RECORD OF SIGNIFICANT FINDINGS and ACTION PLAN.

ADDRESS: Grenfell Tower, Grenfell Road London W11 1TQ

DATED: 17th October 2014

Grenfell Tower

GROUND FLOOR

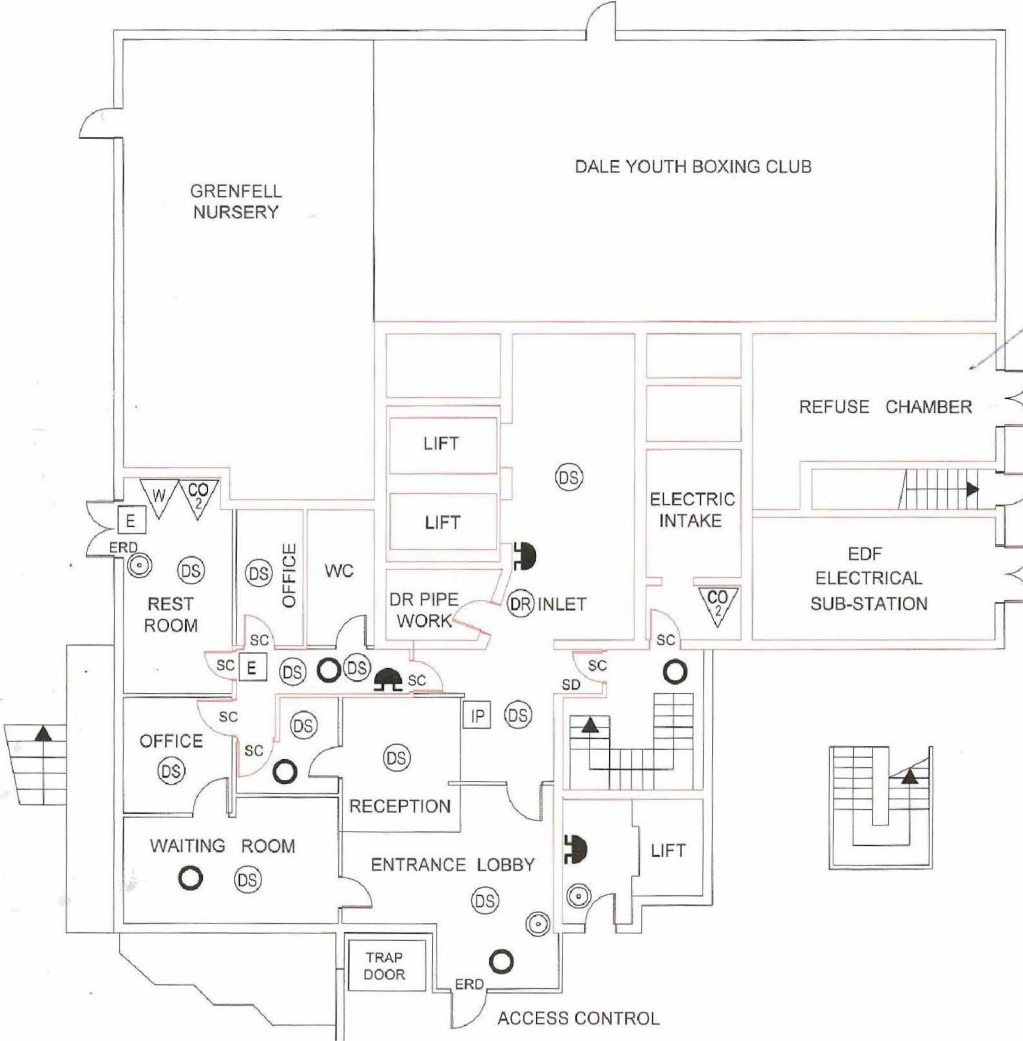
*steel plate
for metal doors*

4th FLOOR

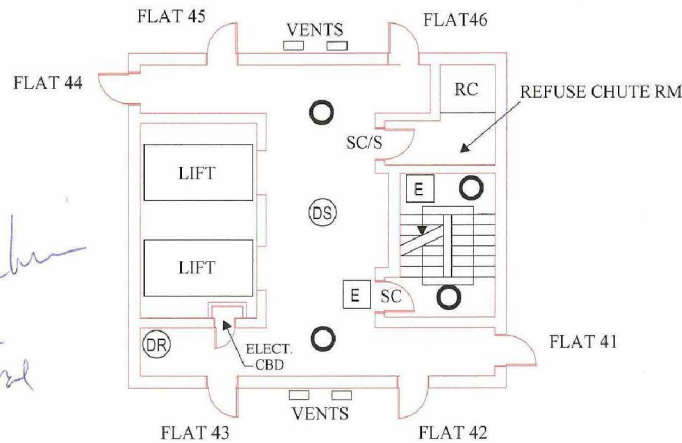
*Show as ~~not~~ see the Card
Down not shut see the Card*

*Repair work between 3 & 4
New beam of duct
P D*

*New entrance Hall
Down challenges
Fire Access*

*Walking cabinet
fall to use
cable
signifying
walking
Exit sign ↑
should be
diminished.*

15th Floor

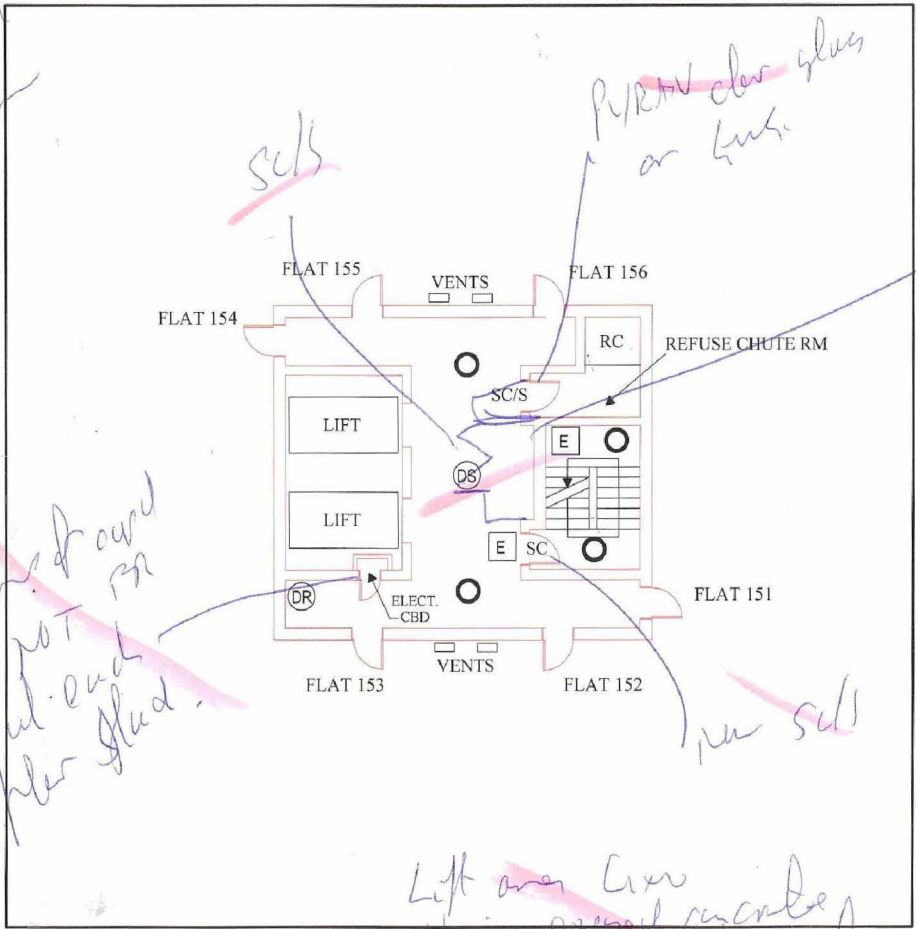
~~new~~
~~15th~~
~~floor~~
~~used~~
~~51/11/10~~
~~floor~~
~~no~~
~~padding~~
~~will~~
~~Need~~
~~to~~
~~change~~
~~with~~
~~New~~
~~flurry~~
~~arrive~~
~~lift~~
~~floor~~
~~N^o~~
~~Flat~~
~~N^o~~

~~Lift~~
~~over~~
~~cur~~
~~stair~~
~~open~~
~~curtain~~
~~hall~~
~~but~~
~~metal~~
~~render~~
~~New~~
~~fire~~
~~curtain~~
~~install~~
~~special~~
~~alarm~~

Roof Level

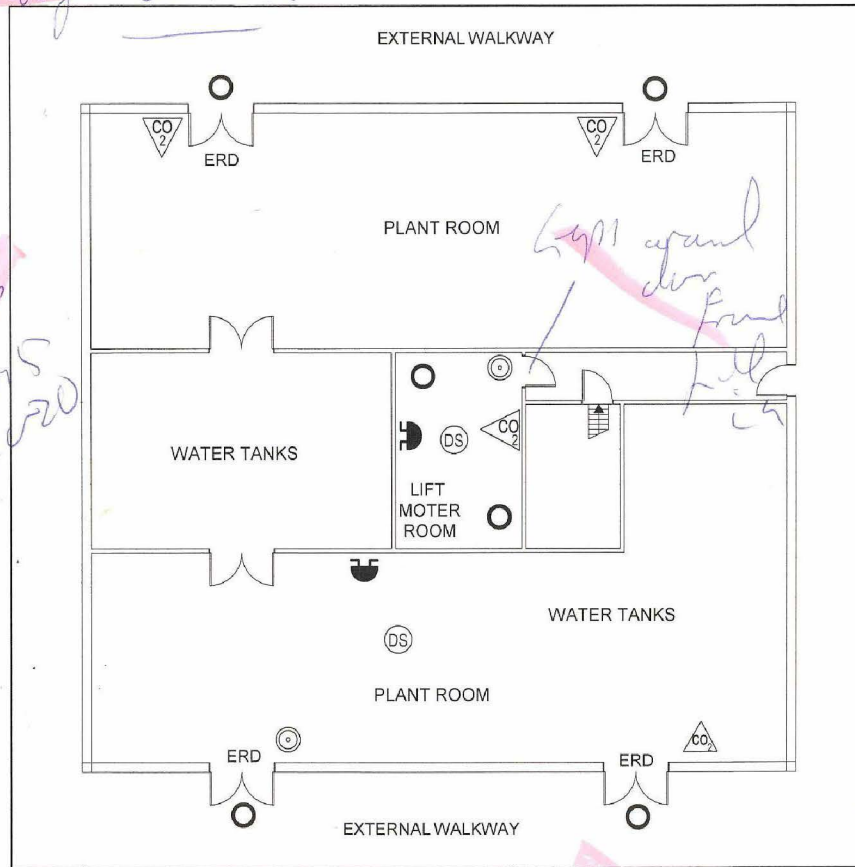
*16-3-16
Lifts
out the lift
CITRSD*

*Water
control
relief tanks
at this level*

*Hold
with
lift*

*ADD BT
Turf storage*
